June 15, 2016

SUBJECT: Addendum 3
API 1509, *Engine Oil Licensing and Certification System*
17th Edition, September 2012 (Addendum 1 October 2014)

Figure 8—Representative Examples of the API Service Symbol

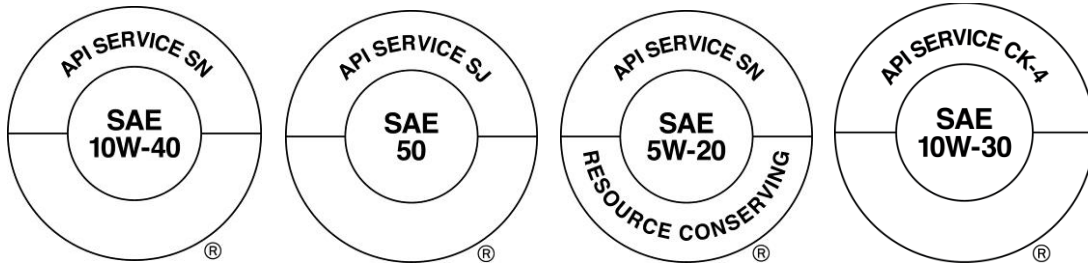
If API C Service Category oils are licensed for more than one current Service Category, these oils may display the Service Categories in the upper part of the API Service Symbol. Except as specified above, if the engine oil marketer chooses to include API C Service Categories with a current API S Category, a virgule (/) must be placed between the API S Service Category and the API C Service Categories, which are separated by commas. Licensees of Service Category C oils may use the C Categories first. Examples of acceptable notations are “API Service SN”; “API Service CJ-4,CI-4/SM”; “API Service SJ”;

“API Service CJ-4/SM”; “API Service CI-4”; and “API Service CH-4.” Figure 8 shows examples of notations for various Service Categories used within the API Service Symbol.
